Descriptive Report to Accompany Hydrographic Survey H11901

Project OPR-P184-RA-08

Pavlof Island, AK

Revisions and Corrections During Office Processing and Certification

Figure 17: Apparent Overlapping Bathymetry.

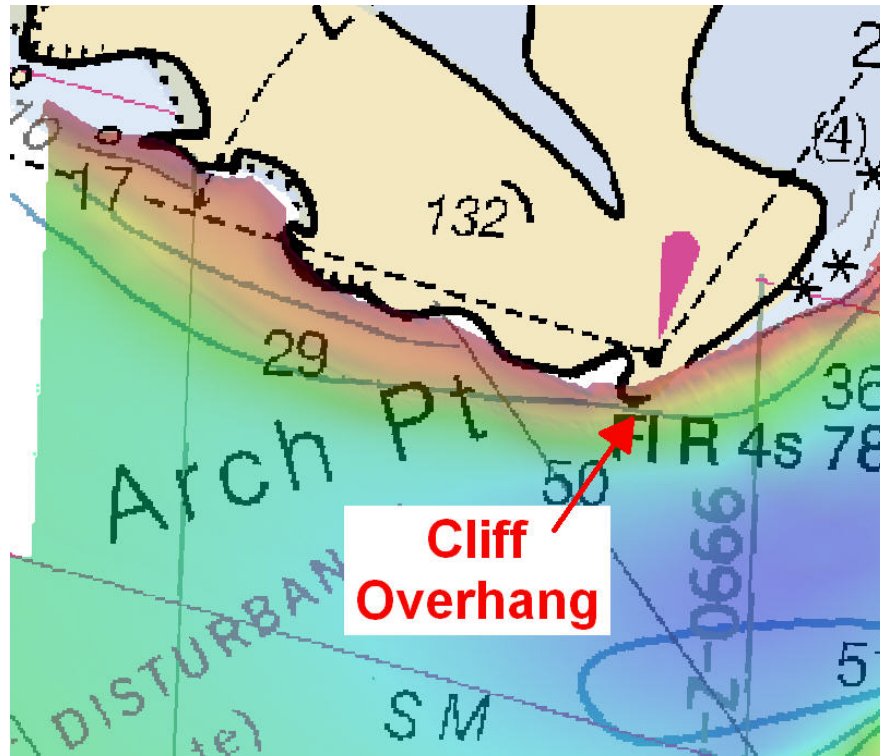
At Arch Point, H11901 survey data appears to overlap the charted (16549) land area (figure 17). This is most likely due to the over-hanging nature of the geography (figure 18) at that place, and possibly due to less than completely accurate shoreline representation.¹⁷

¹⁷ Concur with clarification; the area of bathymetry overlapping the shoreline is much larger than the gap under the arched shoreline, thus the arch is not the cause of the improperly charted land extents. A blue note advising the land extents be adjusted per hydrography has been placed at Arch Pt.

Figure 19: Pile locations 1940 and 2003.

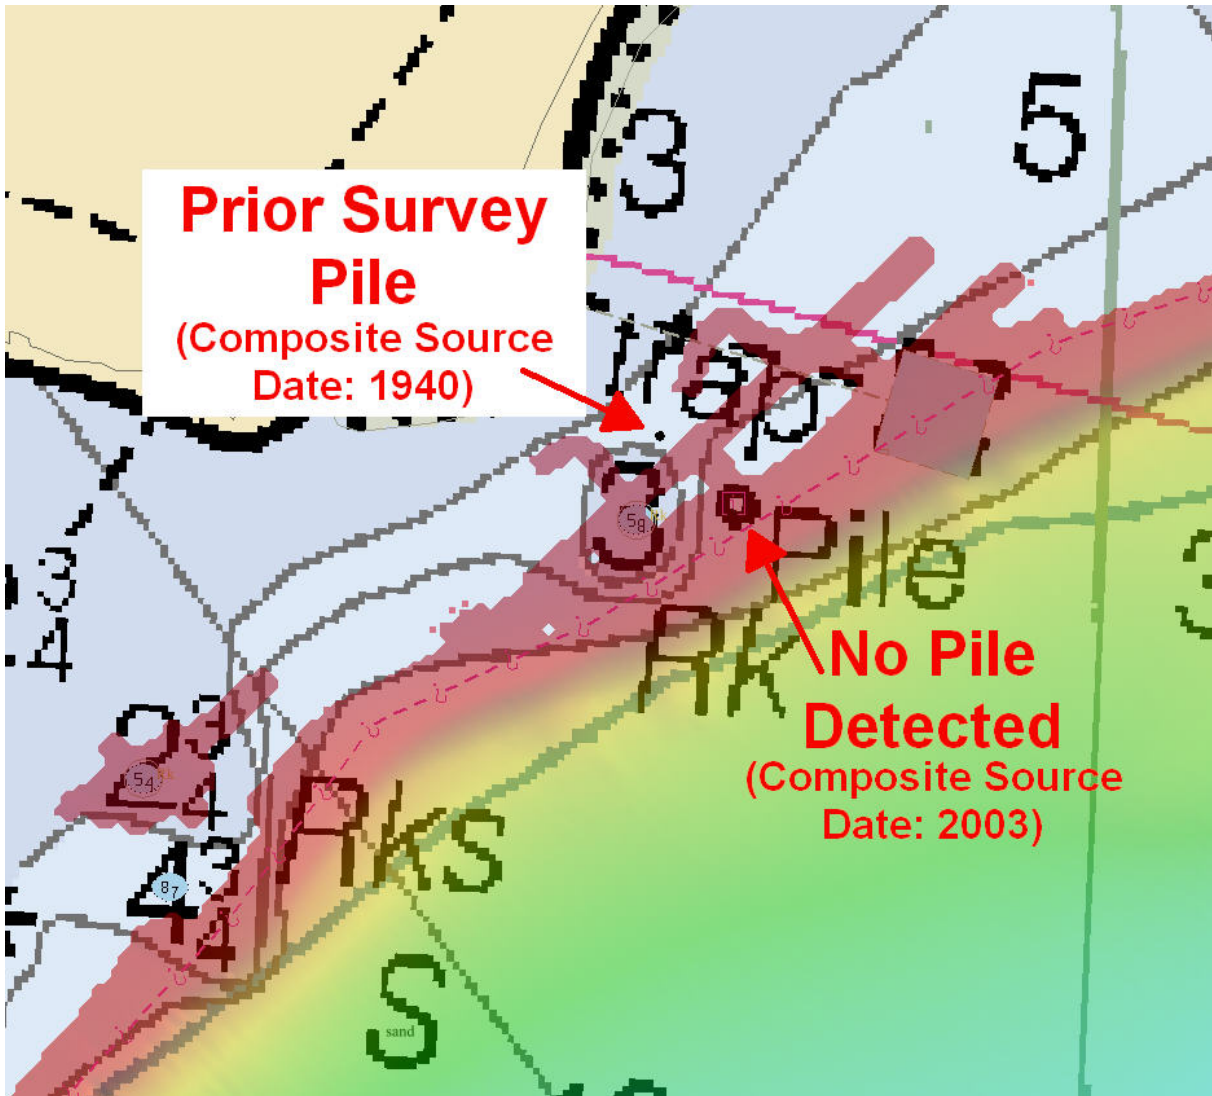
A charted (16549) pile near shore between Arch Point and Long John Lagoon was not detected (figure 19). According to the composite source .hob file, the charted pile has a source date of 2003, however, a second, uncharted pile feature is present in the same layer with a source date of 1940. It may be that both comp source features represent the same pile, but for cartographic reasons, the pile was moved from its 1940 position, further offshore to where it is currently charted. The hydrographer recommends deleting the pile as charted, however because no data were acquired over the pile's 1940 location, no recommendation for recharting is included.¹⁸

¹⁸ Original pile at 55-12-59.0N, 161-52-59.1W has been selected for charting. The charted pile that was disproved at 55-12-56.1N, 161-52-53.8W is recommended to be removed.

Figure 20: Islet recommended for deletion, and Land Area to be retained.

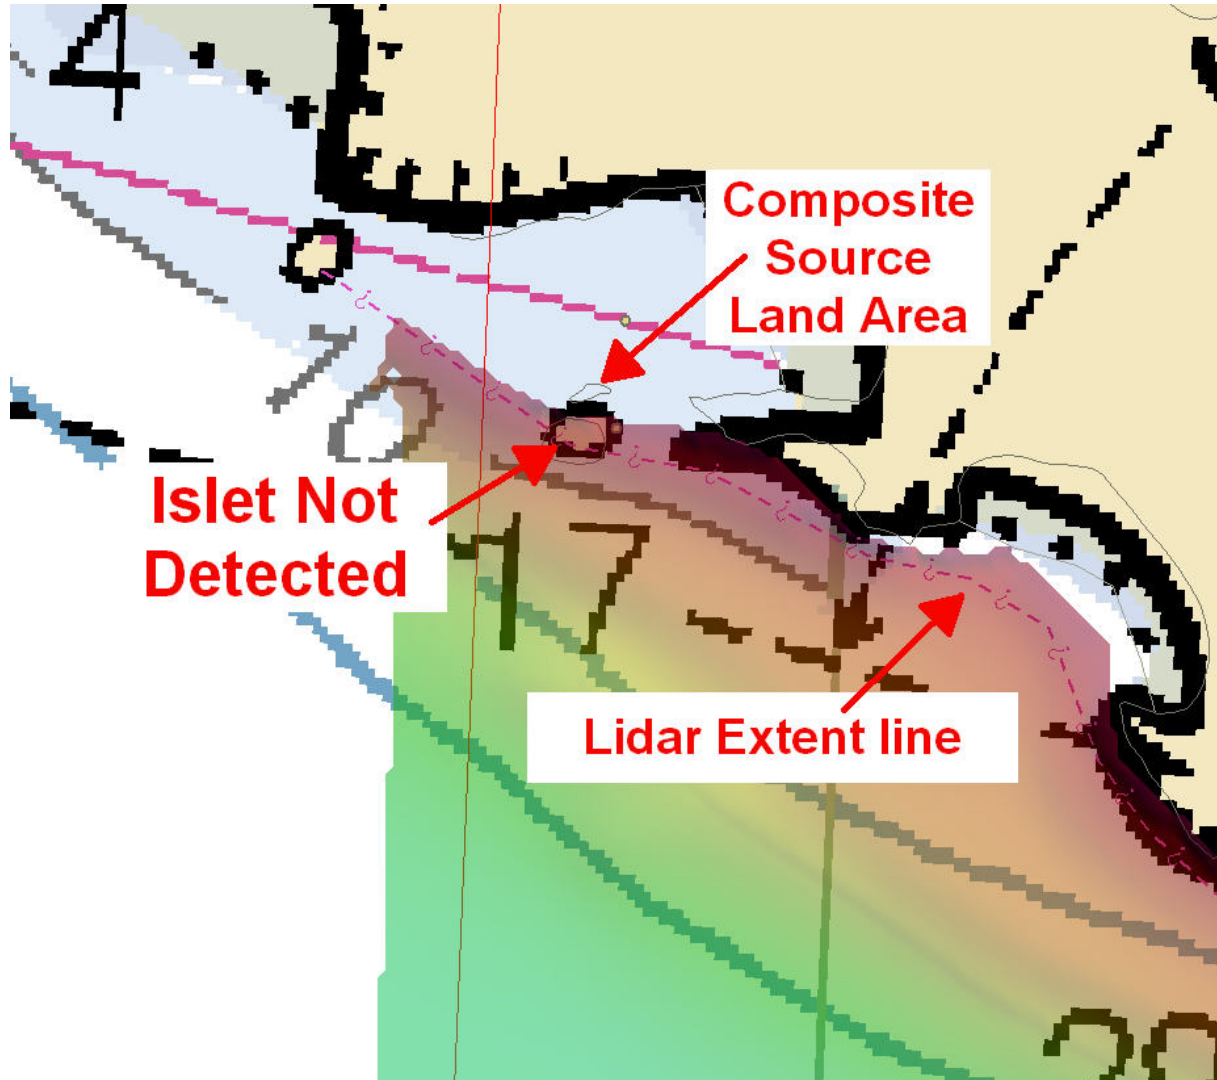
West of Arch Point, near the far northwest limit of the survey, a charted (16549) islet was not detected; the hydrographer recommends deleting it from the chart (figure 20). The composite source layer shows another land area just inshore of this islet. Recommend charting as per lidar data.¹⁹

¹⁹ Concur with clarification. Due to the overlap between surveys H11900 and H11901 this feature was addressed in H11900, however the actions chosen during the compilation of H11900 are in agreement with the recommendations made by the field.
